Lustertone[®] Deep Single Bowl Sink Models DLR and DLRQ Series

Project Name: Webster University-**ISB**

Copies	No.	Description
1 PDF	224216P02	(Submittal No.'s)
		(Cannon #22 4216.16-001) - (Paric #15051-) - (WES #607)
		➤ Commercial Sinks
		• Clinical Service Sink CSS-1
		• Scrub Sink SS-1
		• Sink SK-1
		• Garbage Disposer GD-1
		• Sink SK-2
		• Sink SK-3
		• Mop Sink MS-1
		• Kitchen Sinks KS-1, KS-2, KS-3

SPEC SECTION: 22 4216.16
Commercial Sinks

KS-3 KITCHEN SINK

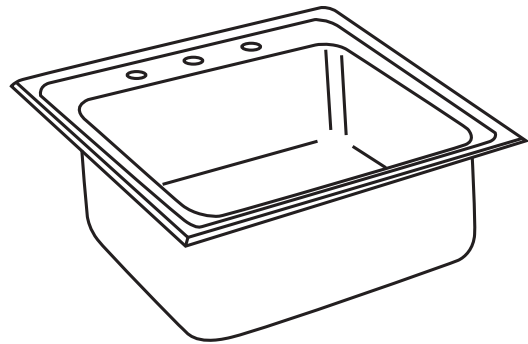
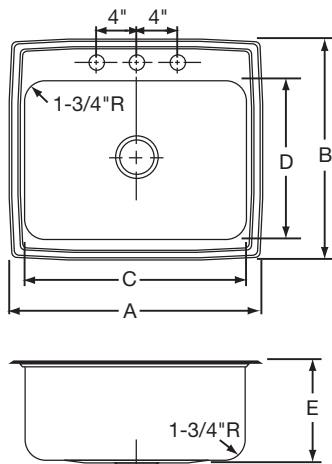
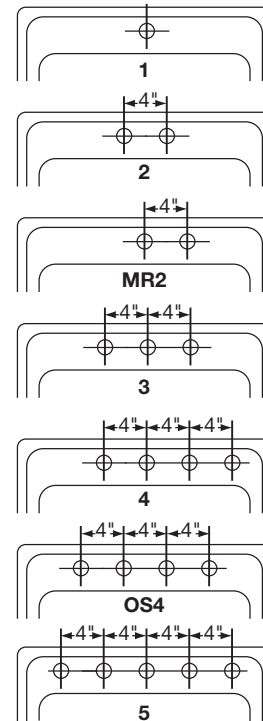
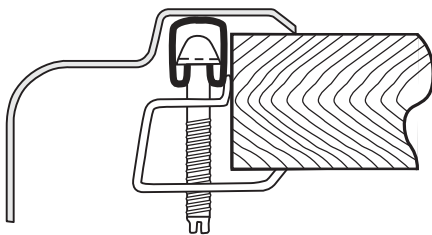
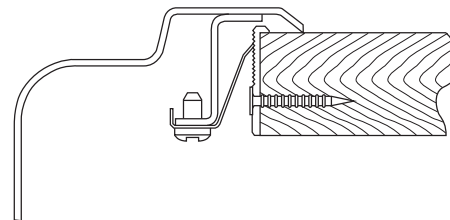
1. Provide under counter waste and supply protective piping covers as required.
Verify requirements with the architectural drawings.
2. Escutcheons are specified to be cast brass. Refer to specification section 220518.
